HURRICANE CITY UTAH

Hurricane Planning Commission Meeting Agenda

November 10, 2022
5:00 PM

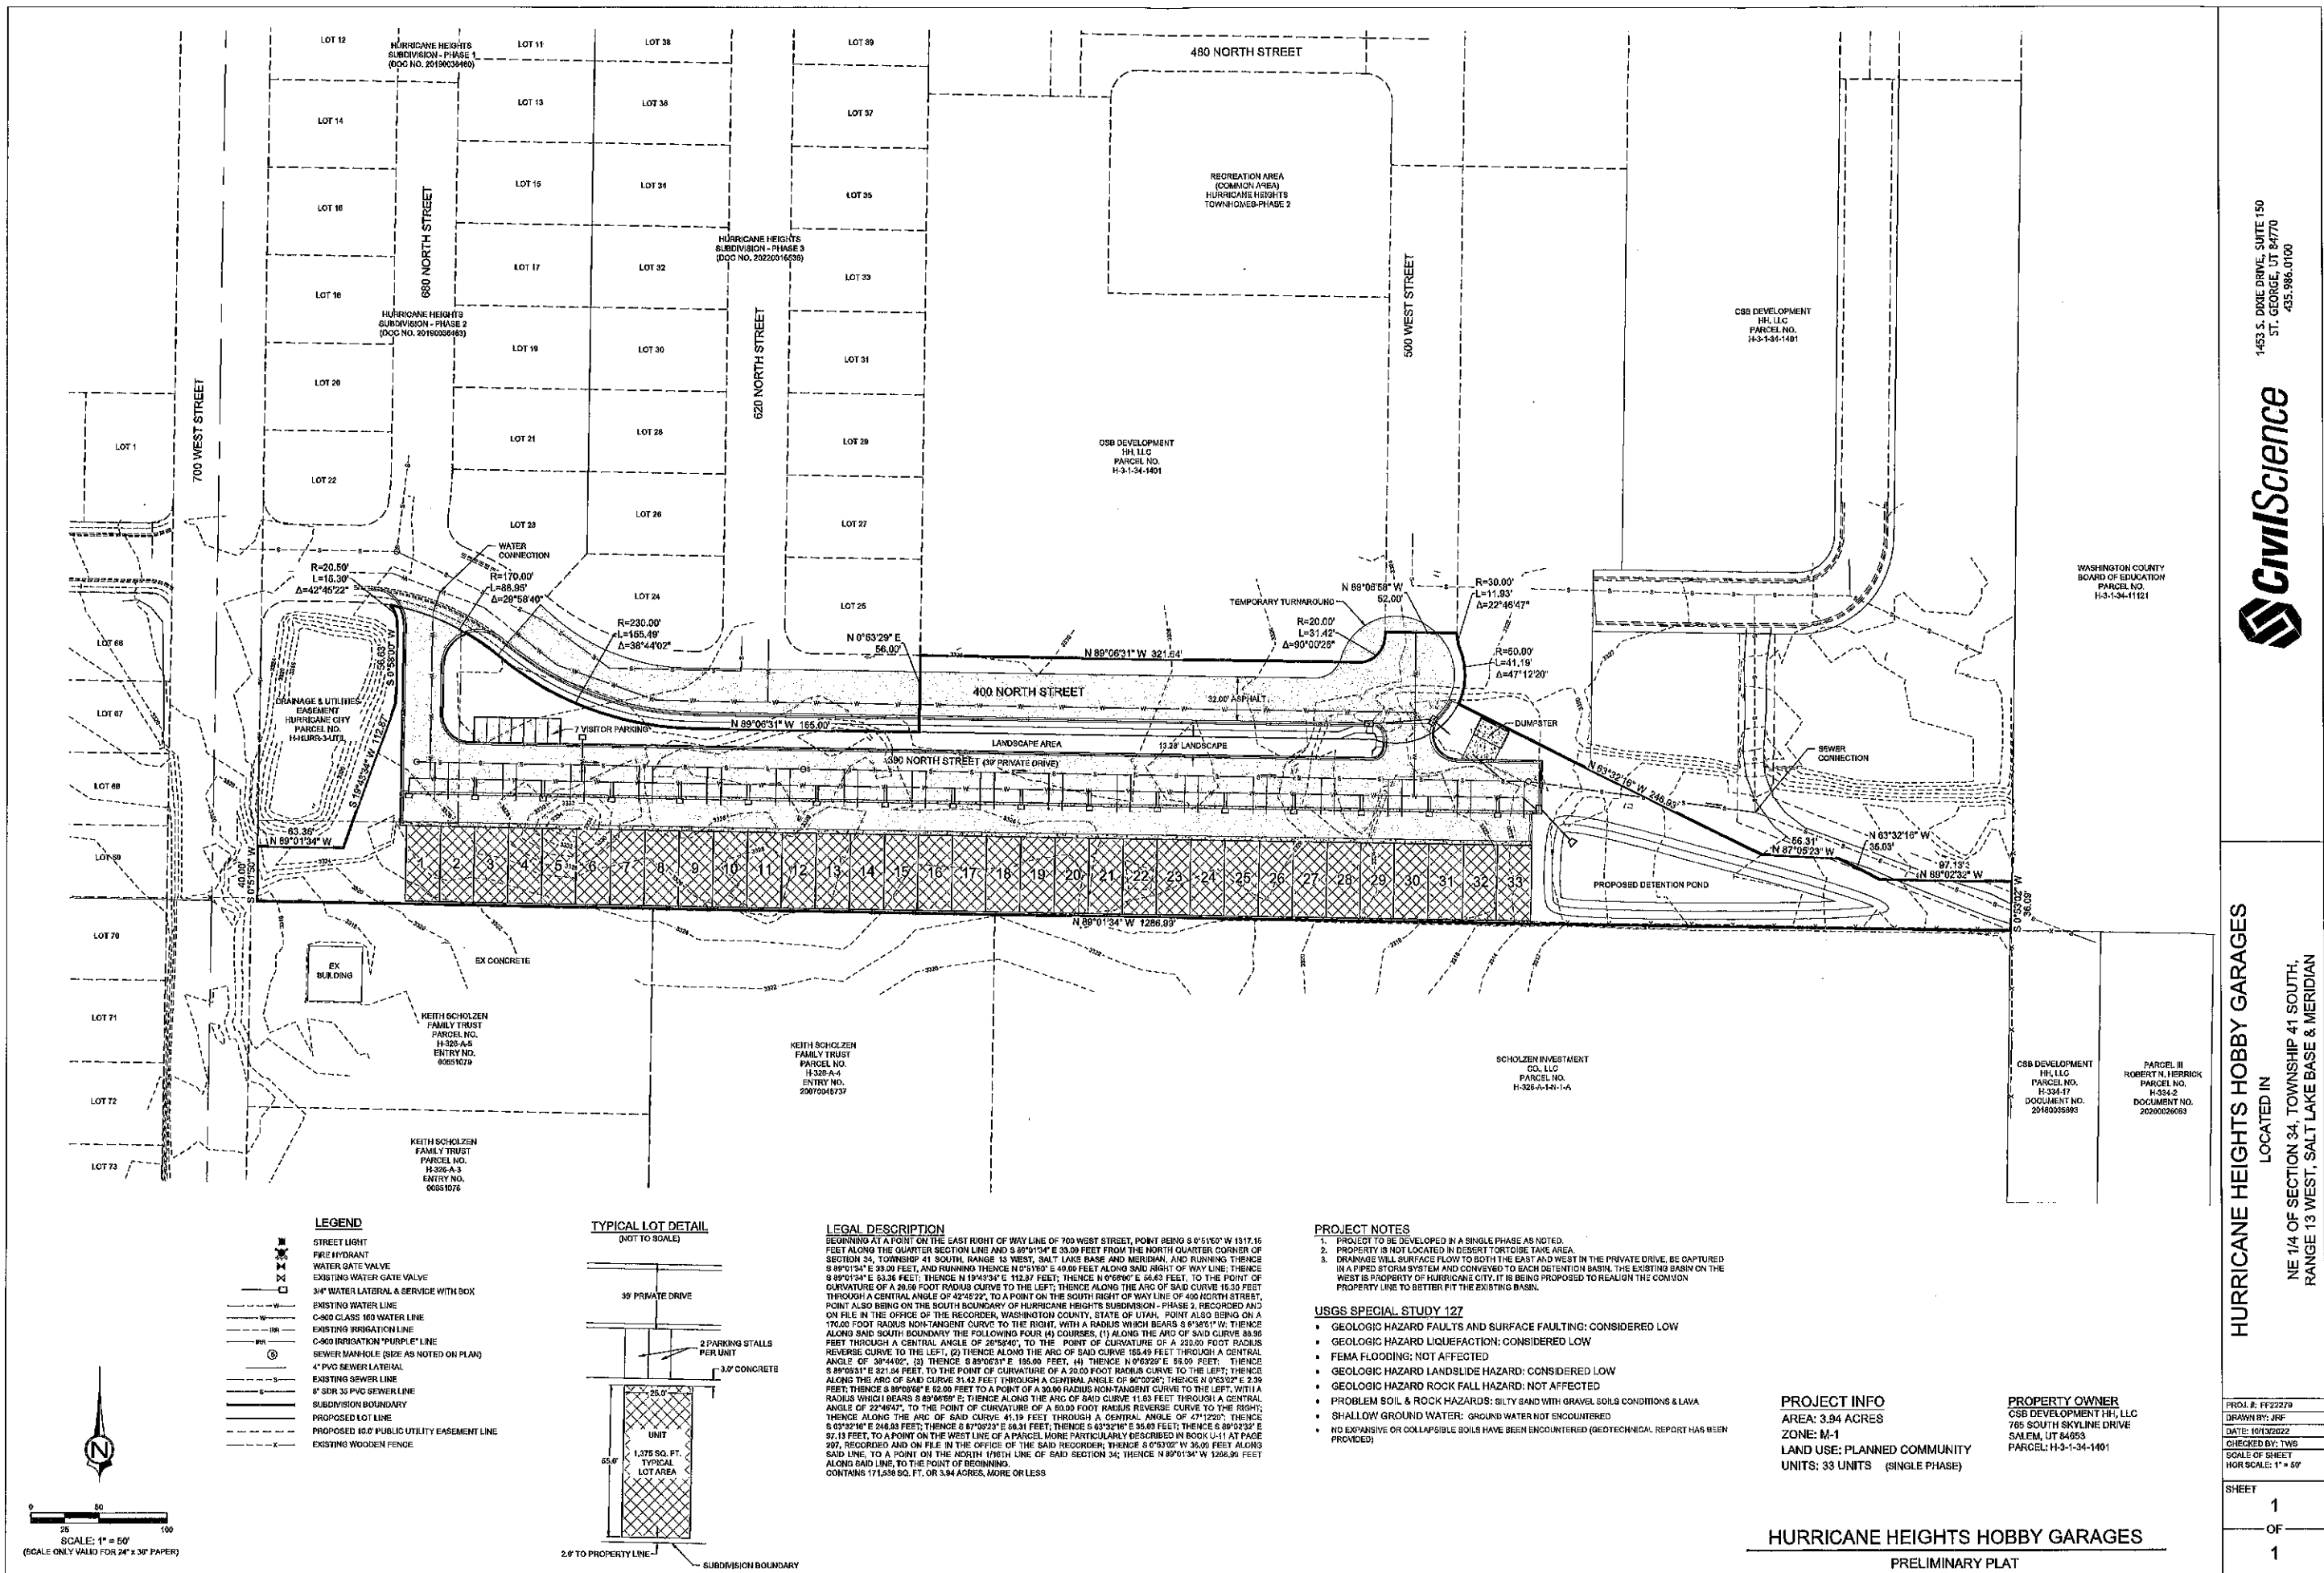
1. **Public Works:** No comments
2. **Power:** Developer must fill out construction application for the power department. Developer must provide info as to power needs per unit. Developer must meet with power before proceeding with this project. Power is developed to the north side of 400 N.
3. **Sewer:** Provide easements of 25' over existing sewer line and an all weather road.
4. **Street:** Consider a larger visitor parking area. Would like to see 400 N as a "No Parking" area to minimize clutter from garages.
5. **Water:** No comments
6. **Engineering:** Legal description needs some corrections. How does stormwater currently get in and out of the existing retention basin? 400 N is an existing 56' Public ROW, should continue as a public street. What is the proposed cross-section? It appears this development is dependent on

the completion of the rest of Hurricane Heights Townhomes. Where is the proposed inlet and outlet to the eastern detention pond? Additional grading detail should be requested. It's difficult to negotiate elevation differences at property lines without a building setback. Property swap may require a plat amendment to Hurricane Heights Phase 3. Improvements for 700 W, a planned 70' ROW, will be required at this phase.

7. **Fire:** Need hydrants. Turnaround is okay. Must have secondary access functional
8. **Cable:** No comments
9. **Gas:** No comments.
10. **Water Conservancy:** No comments
11. **GIS:** No street name needed on private drive

1. Zoning is M-1, light industrial, and storage units are an approved use in M-1. No residential uses are permitted in M-1 zoning.
 - a. There are no setbacks between lots zoned M-1

Recommendation: Staff recommends the Planning Commission review this application based on standards with Hurricane City Code. Staff recommends approval subject to staff and JUC comments as well as receipt of will serve letters.

LANDSCAPE
PLAN
L100

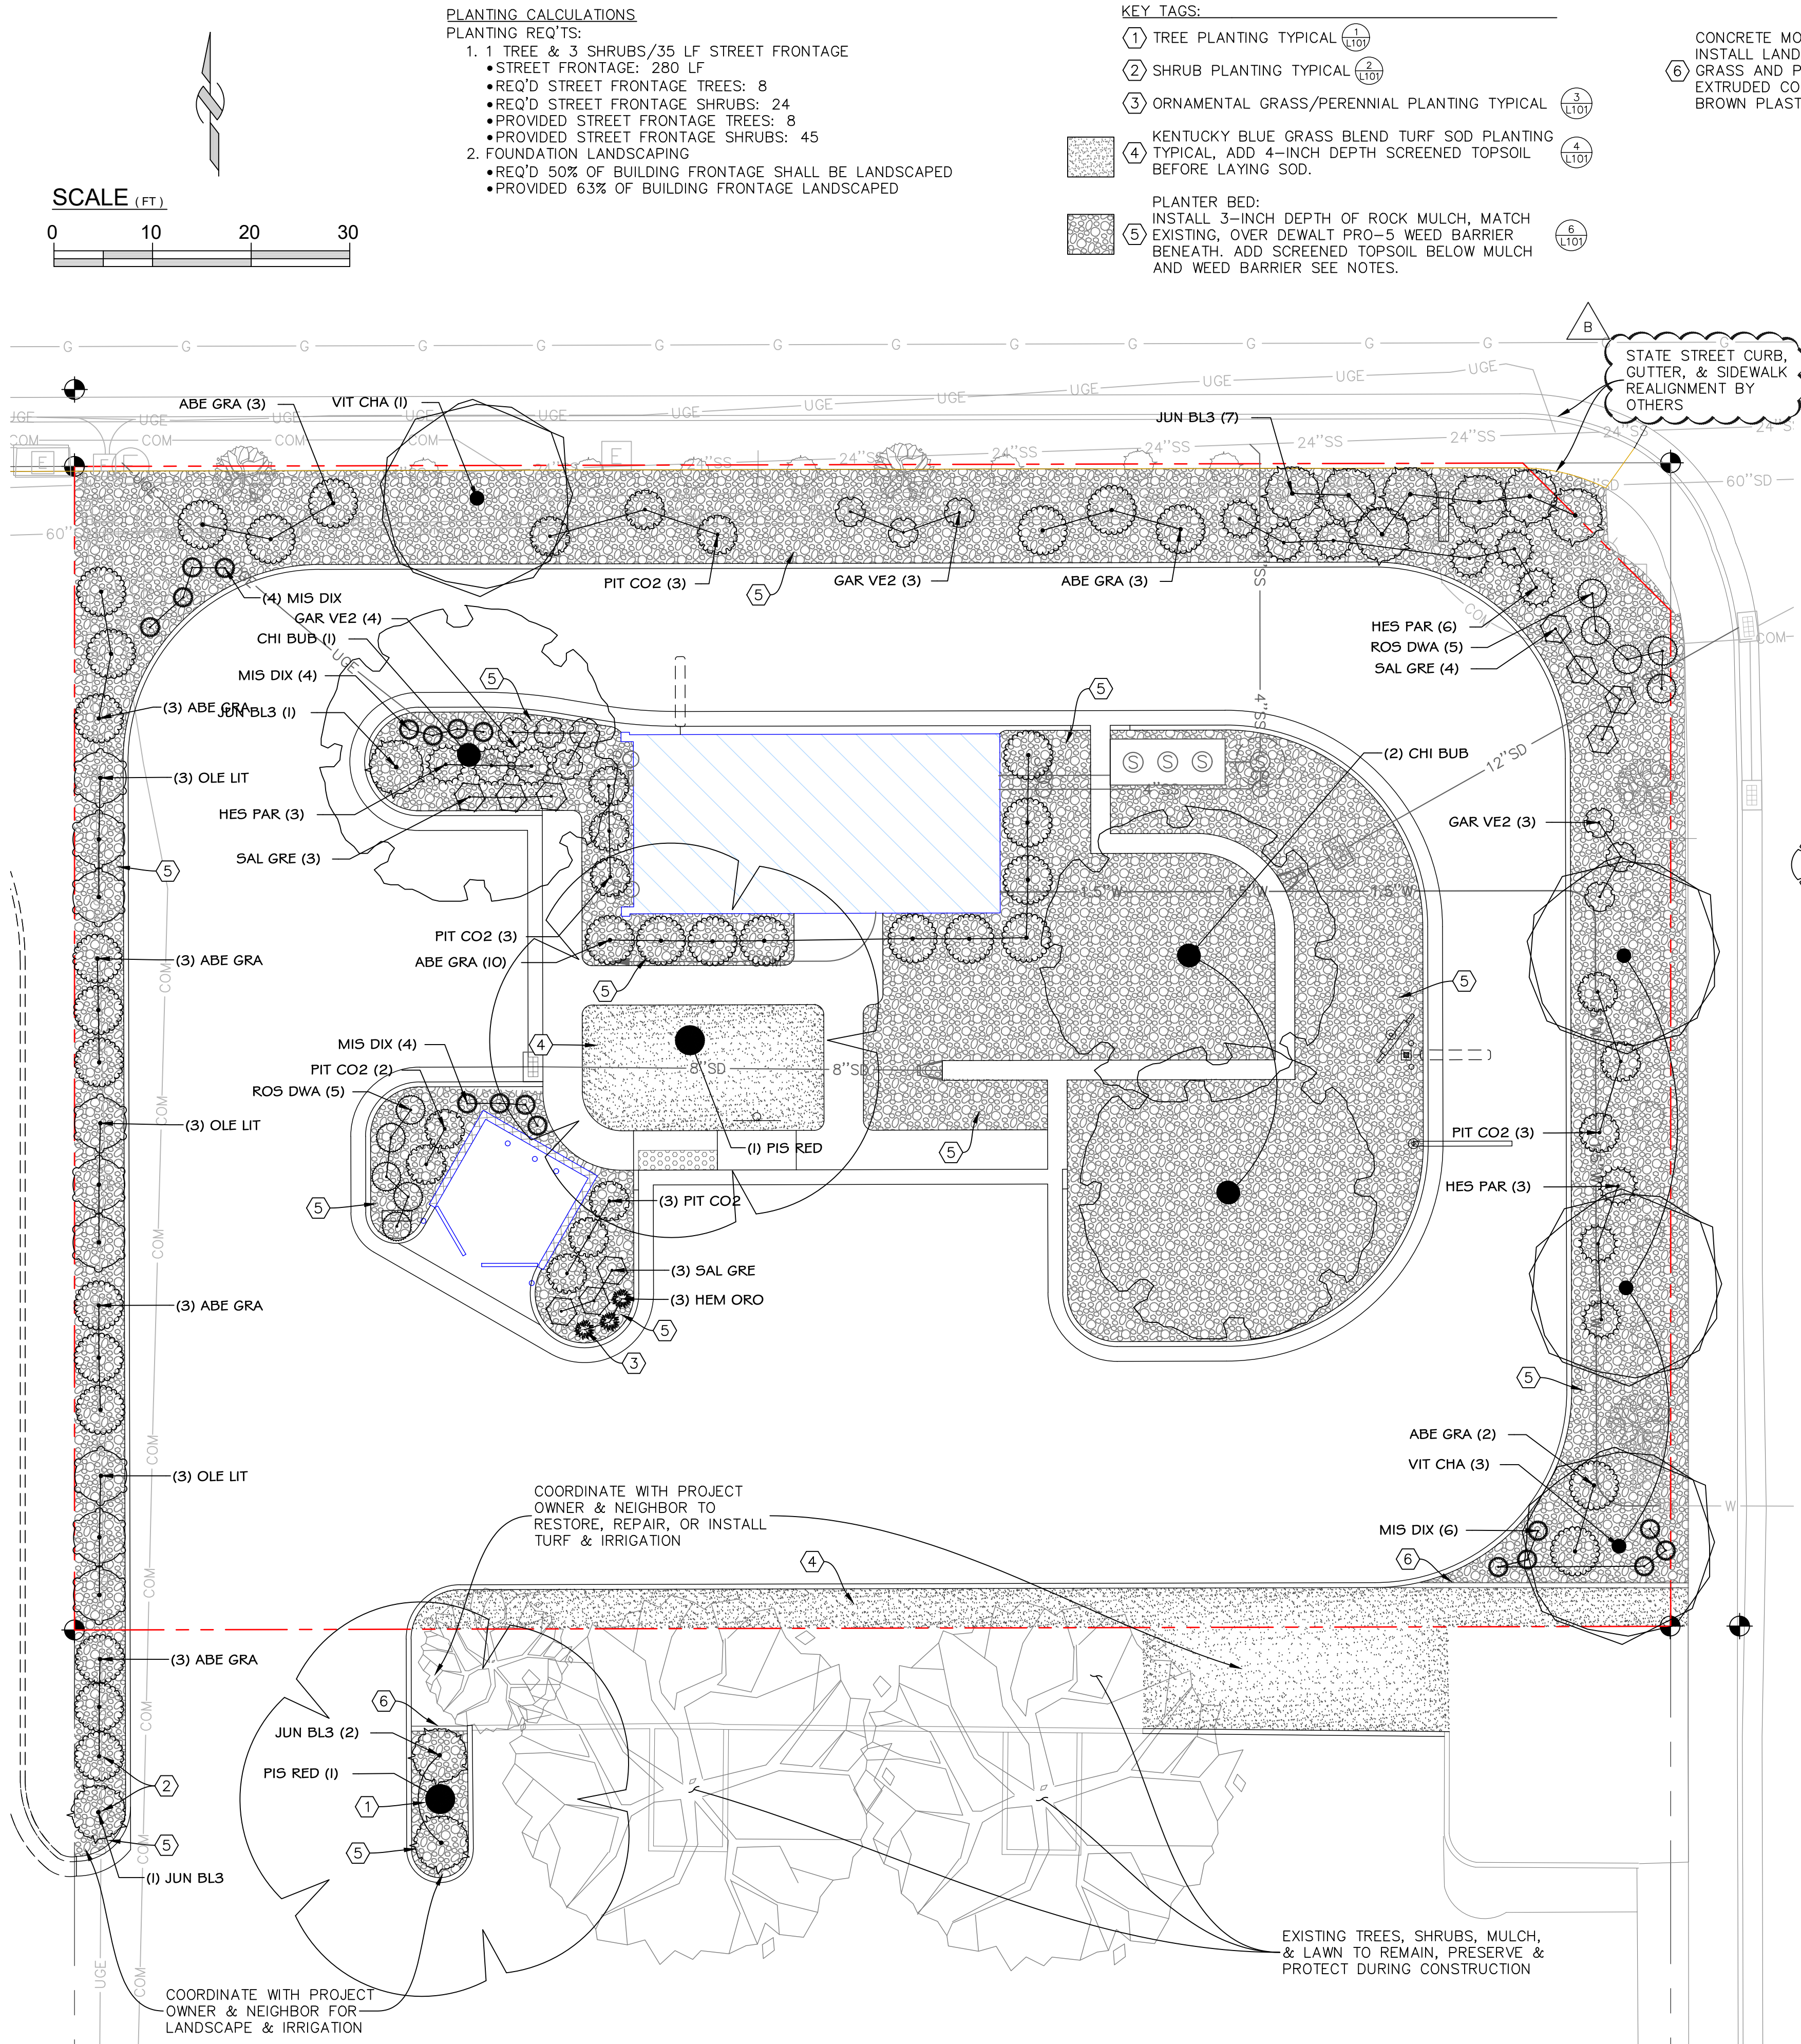
1. The layout, setbacks, and sizes comply with zoning standards and the preliminary approval.
2. **Landscaping:** A landscaping plan has been provided.
 - a. The site requires 8 street trees and 24 shrubs. The applicant is proposing that the trees to be planted around the building count towards the street tree requirements. Staff finds this acceptable to avoid potential sight issues on the corner of 700 W and State St. The Planning Commission may approve noncompliant landscaping plans under HCC 10-32-4: 10-32-4. - *Deviation from strict compliance.*

- b. The plan shows an area of grass turf; it appears that part of the grass area shown is on the City's property and was likely intended to match the existing conditions. All existing grass turf can stay but no new grass should be added per HCC 10-32-11

- a. An amended landscape plan that matches city code with regards to grass turf and a written statement asking for a deviation for the placement of the street trees
- b. A new access easement is approved by the City Council
- c. The Zoning Administrator signs off on lighting fixtures.
